**ADDENDUM NO. 3**

Densmore Park Backstop Replacement - 2006  
Lincoln Parks and Recreation  
Specification No. 07-003  
OA Project No. 2006-1639

**ADDENDUM #3**  
**DENSMORE PARK**  
**LINCOLN, NEBRASKA**

## FASTENING DETAIL

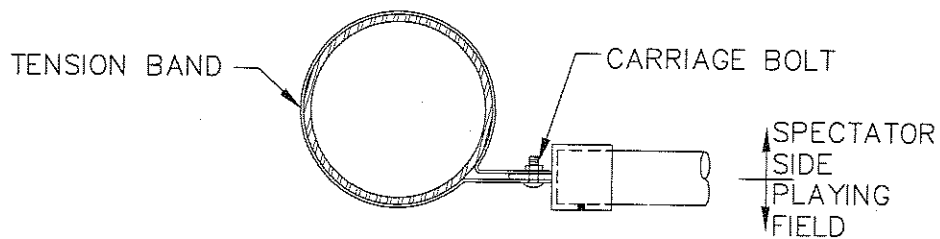
"New Backstop Posts shall be installed at the same location as those that are being removed."
  - c. Add the attached Fastening Detail which provides information relative to connecting the top, bottom and intermediate rails with the line posts.
